SERVICE NO. 1331A BULLETIN

Date: September 27, 2018

Service Bulletin (SB) 1331A supersedes SB 1331 in its entirety. Aircraft that were previously made compliant with SB 1331 are in compliance with SB 1331A.

STABILATOR IDLER ARM ASSEMBLY INSPECTION

Figure 1
Stabilator Idler Arm Assembly Location

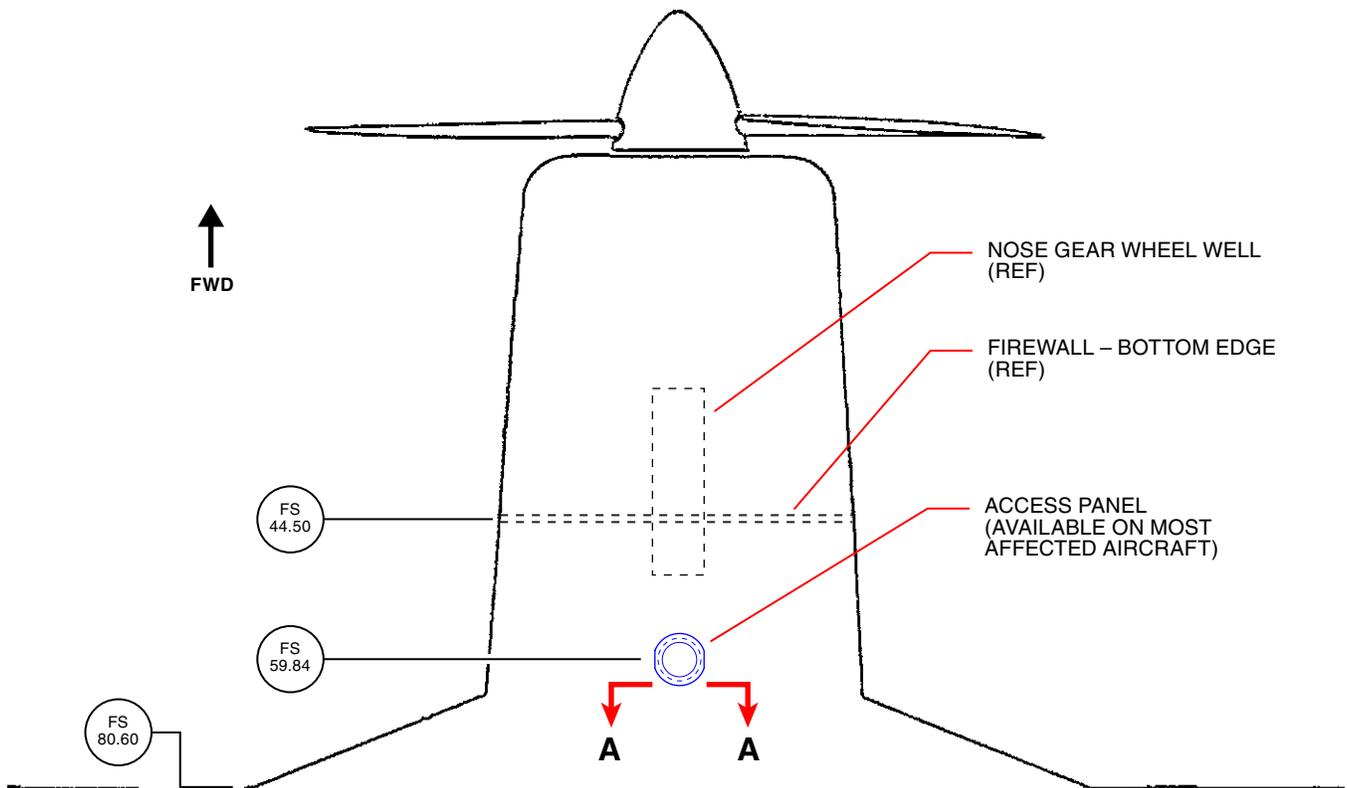
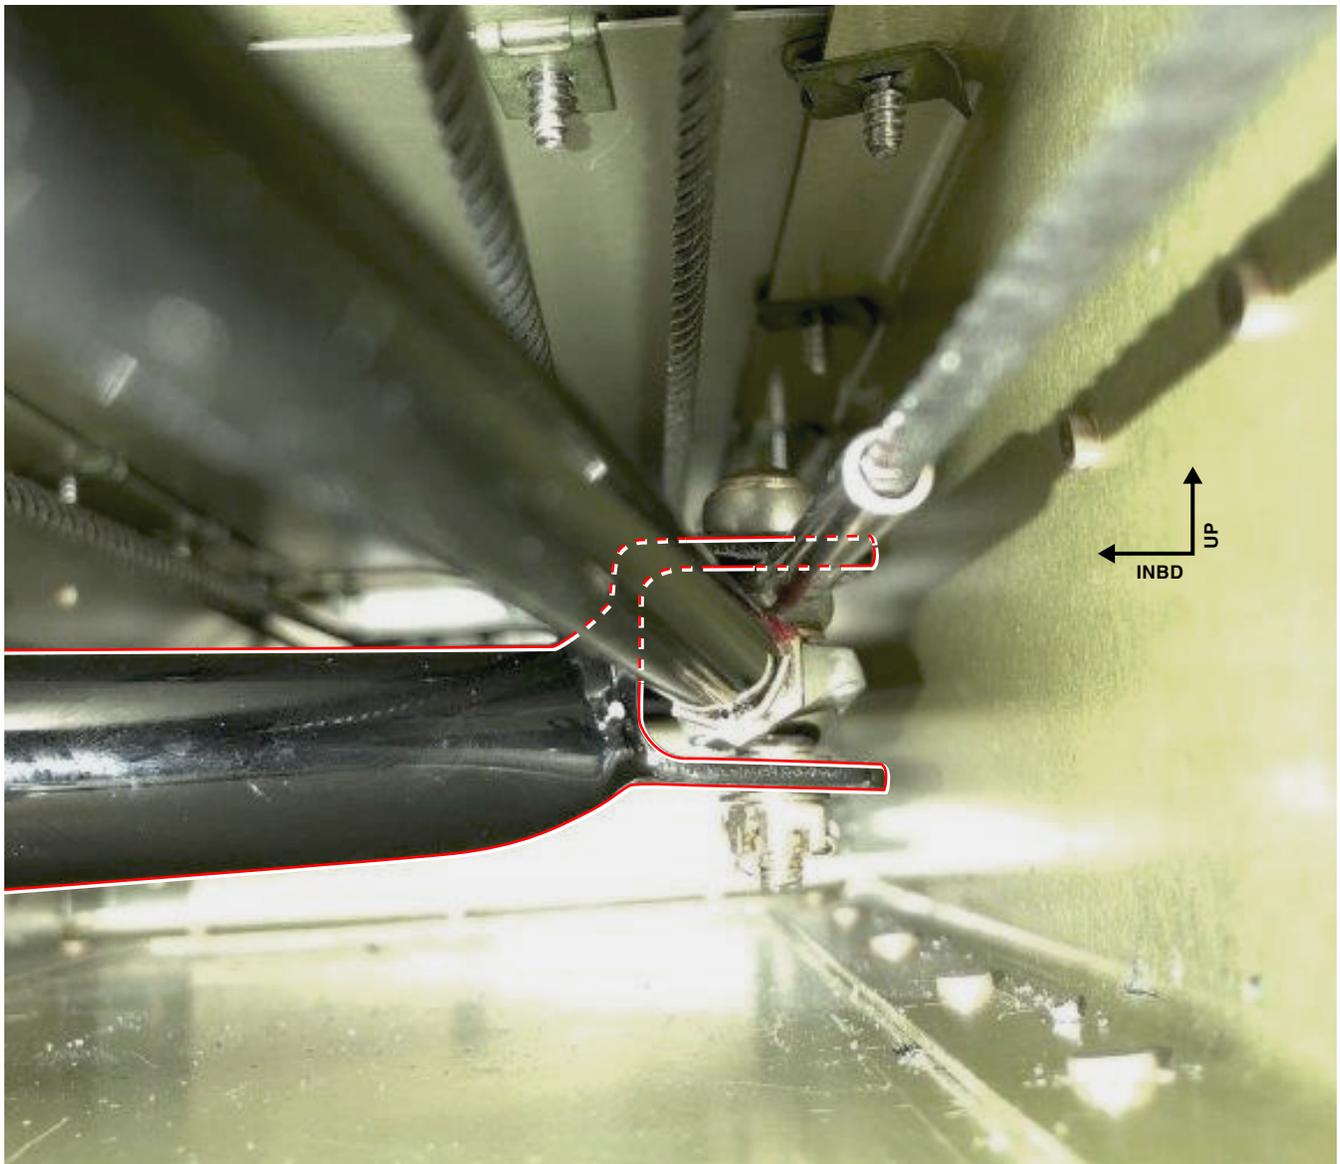
1. Remove the circular access panel that is directly aft of the nose gear wheel well opening, as shown in Figure 1.
NOTE: Some of the affected models do not have the access panel shown in Figure 1. For those aircraft, temporary removal of components on the top surface of the tunnel will provide access for this inspection.

2. Looking aft through the tunnel, examine the orientation of the Stabilator Idler Arm Assembly, Piper part number (P/N) 67066-000, and compare that to the orientation of the part in Figure 1, View A–A, and Figure 2, which shows P/N 67066-000 correctly installed. A properly installed P/N 67066-000 will have the clevis positioned above the tube.

- 2) Remove P/N 67066-000 and reinstall it in the proper orientation, per the appropriate Piper Airplane Maintenance Manual, Section 27-30-00, or Service Manual, Section V.
